om 3160-5 CO CO ED STATES N.M. Oil Cons. Doc.	Vila ma
une 1990) DEPARTMENT OF THE INTERIOR VV. Caracia A	FORM APPROVED (
DEPARTMENT OF THE INTERIOR W. Grand Bureau of Land Management Ariesia, No. 30	Budget Bureau No. 1004-0135 Expires: March 31, 1993
In CHARDANA AND DEBORTS ON WELLS	Lease Designation and Serial No.
Do not use the form for proposals to drill or to deepen or reentry to a different reservoir.	NM 0556590
Use "APPLICATION FOR PERMIT —" for such proposals	6. If Indian, Alottee or Tribe Name
Year.	7. If Unit or CA, Agreement Designation
OU CAS TO TRIPLICATE	
Type of Well: WELL OTHER	8. Well Name and Number FEDERAL 33 GAS COM
Name of Operator CHEVRON USA INC	3
Address and Telephone No. 15 SMITH ROAD, MIDLAND, TX 79705 915-687-737	9. API Well No. 30-015-32180
Location of Well (Footage, Sec., T., R., M., or Survey Description)	10. Field and Pool, Exploaratory Area
nit Letter K : 1980 Feet From The SOUTH Line and 2080 Feet From The	INDIAN BASIN,UPPER PENN, & MORROW

Re: ChevronTexaco's Fed Com '33' #3 Surface Location: 1980' FSL & 2080' FWL Proposed BHL: 1980' FSL & 1980' FWL Section 33, T21S, R23E, Eddy County, N.M.

WELL LOCATION AND ACREAGE DEDICATION PLAT

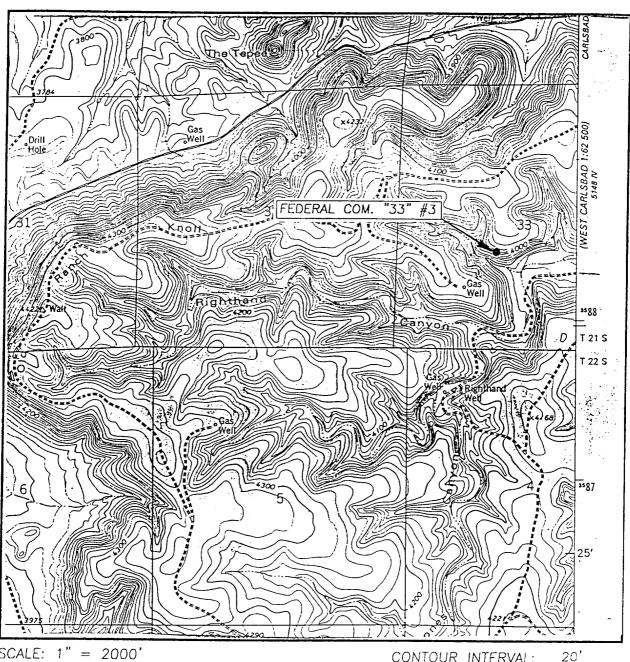
Per the attached permit, this previously approved well is to be drilled in the very near future (planned spud - early November) as a dual completion in the Indian Basin Upper Penn and Loafer Draw Morrow pools. The well was previously permitted and approved at a surface location of 1880' FSL & 1980' FWL. The purpose of this letter is to explain the circumstances requiring movement of the proposed surface location and to convey ChevronTexaco's intent and plan to ensure an orthodox location prior to entering the Morrow formation.

Due to topographic, archeological, and surface facility concerns, the most acceptable location in the SW quarter of the section 33 from which to drill is 1980' FSL & 2080' FWL. A similar bottom hole location would be orthodox for the Indian Basin Upper Penn pool but would be unorthodox for the Loafer Draw Morrow pool (statewide rules). In order to achieve an 'orthodox location' status in both pools and a higher structural penetration point within the Morrow reservoir, it is our intent to steer the well, prior to the Morrow reservoir penetration point, to a subsurface location at a maximum distance of 1980' FSL & 1980' FWL. Survey data will be provided to verify this result.

UL or lot No.	Section	Township	Range	Lot Idn	Feet from the	North/South line	Feet from the	East/West line	County
K	33	21-S	23-E		1980'	SOUTH	2080'	WEST	EDDY

UL or lot No.	Section	Township	Range	Lot Idn	Feet from the	North/South line	Feet from the	East/West line	County
	K	33	21-5	23-E		1980'	SOUTH	1930'	WEST	EDDY
1	Dedicated Acres	Joint o	r Infill Co	nsolidation (Code Or	ler No.				7
	640
